PRODUCT / PROCESS CHANGE NOTIFICATION

1.1 Company		STMicroelectronics International N.V
1.2 PCN No.		MDG/18/11130
1.3 Title of PCN		Extension of AMKOR XDLF SO8N assembly & test line usage to CMOSF8H Industrial Range EEPROM (M24256, M24512, M24M01, M24M02, M95256, M95512, M95M01, M95M02)
1.4 Product Category		EEPROM in SO8N from CMOS F8H process: M24256, M24512, M24M01, M24M02, M95256, M95512, M95M01, M95M02
1.5 Issue date		2018-10-09

Extension of AMKOR XDLF SO8N assembly & test line usage to CMOSF8H Industrial Range EEPROM (M24256, M24512, M24M01, M24M02, M95256, M95512, M95M01, M95M02)

- BOX LABEL MARKING

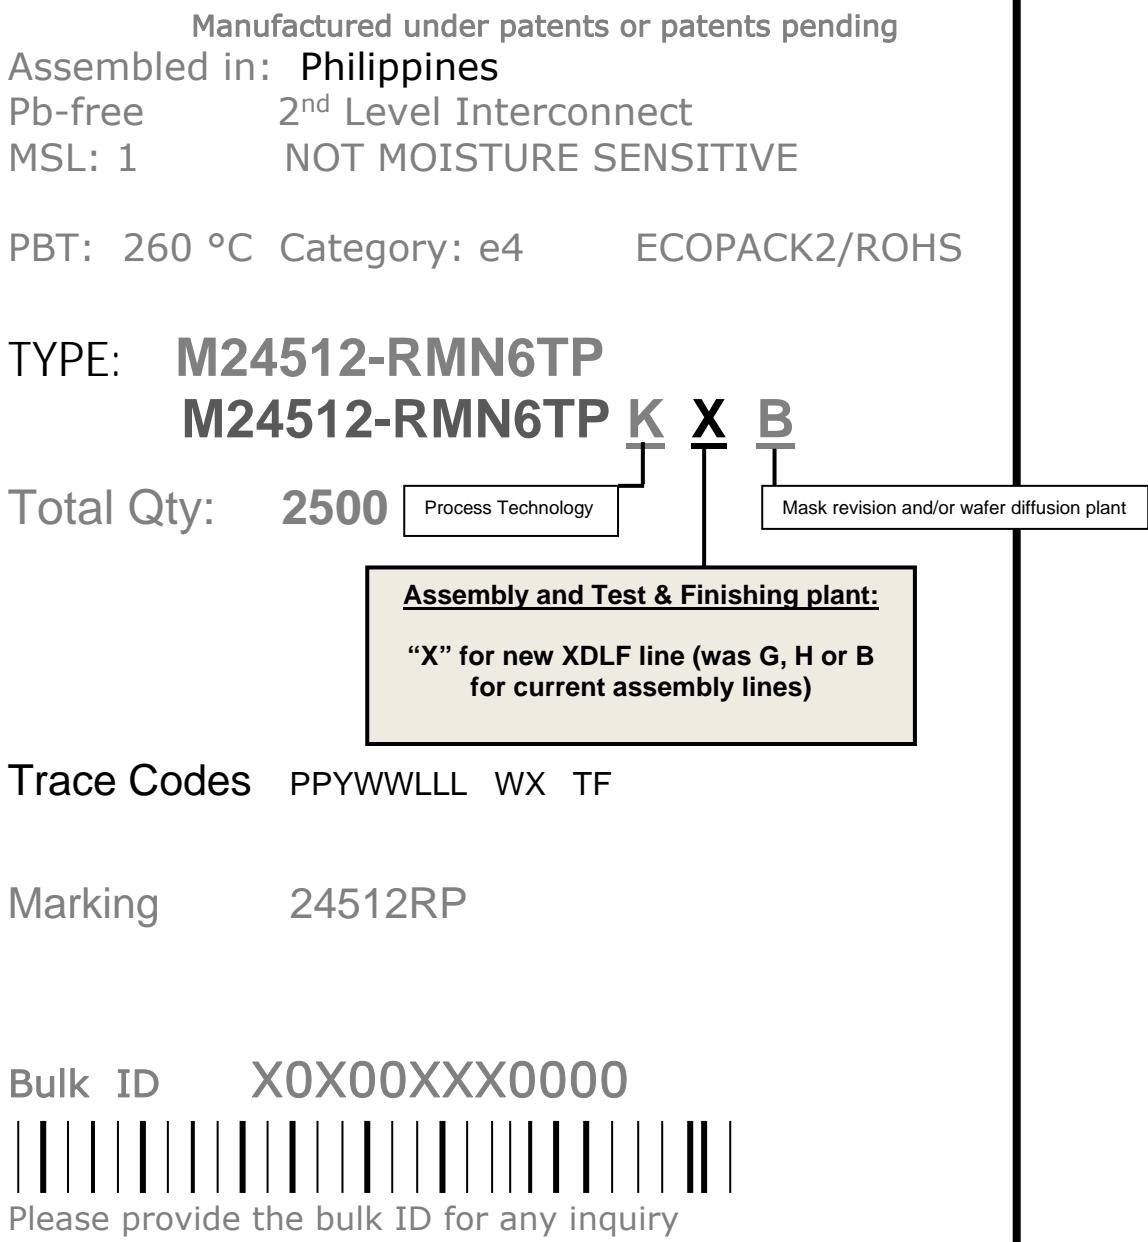
The change is visible on the **BOX LABEL MARKING**, inside the **Finished Good Part Number**: the **Assembly and Test & Finishing** plant identifier is "X" for the **SO8N XDLF** line.

→ Example for M24512-RMN6TP
